**Planning Department
Transportation Development Services**

**Re: Aztec Special Education Facility
2611 Eubank Blvd., NE
Traffic Circulation Layout
Engineer's/Architect's Stamp dated 7-27-15 (H20-D33)**

Based upon the information provided in your submittal received 9-3-15, the above referenced plan cannot be approved for Building Permit until the following comments are addressed:

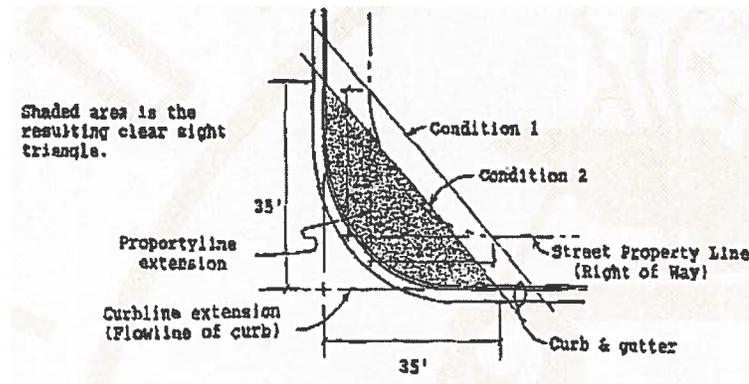
10. The ADA accessible parking sign must have the required language per 66-7-352.4C NMSA 1978 "**Violators Are Subject to a Fine and/or Towing.**"
